Bulletin Number **TPMB-0102 (Revision 3/4/2003)**

Topic **Forced Lube System – Clutch Housing Information**

Halo Versus Non-Halo

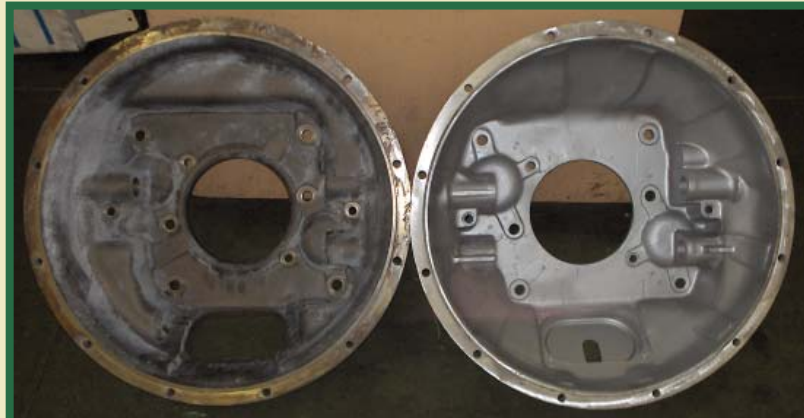
Front of Bell Housing has raised groove

Front of Bell Housing is flat

Back of Bell Housing has groove for oil tubes

On some late transmissions, we have seen Bell Housings with a raised groove in the front, but not machined in the back for Halo System.

Back of Bell Housing is flat

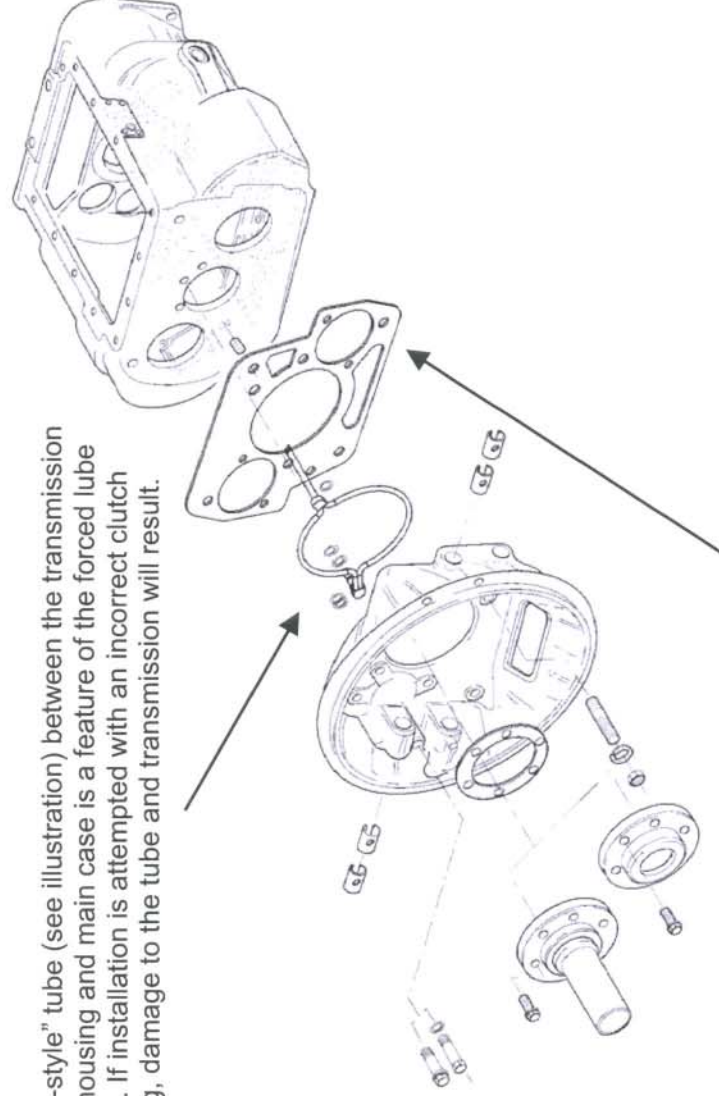
An internal forced lube system has been added as a running change to Eaton[®] Fuller[®] 13 and 18-speed transmissions rated for applications at and above 1650 lbs.-ft.

Important note: If you are replacing a transmission that was not originally produced with the internal forced lube system, you will be unable to reuse the original clutch housing. A clutch housing that is not machined to accommodate the forced lube assembly cannot be installed on a transmission with this feature.

A “halo-style” tube (see illustration) between the transmission clutch housing and main case is a feature of the forced lube system. If installation is attempted with an incorrect clutch housing, damage to the tube and transmission will result.

Note: The correct clutch housing gasket, 4304815 must be used with the forced lube system. The gasket must be in place **before** installing the lube tube assembly with the beaded side facing towards the transmission case.
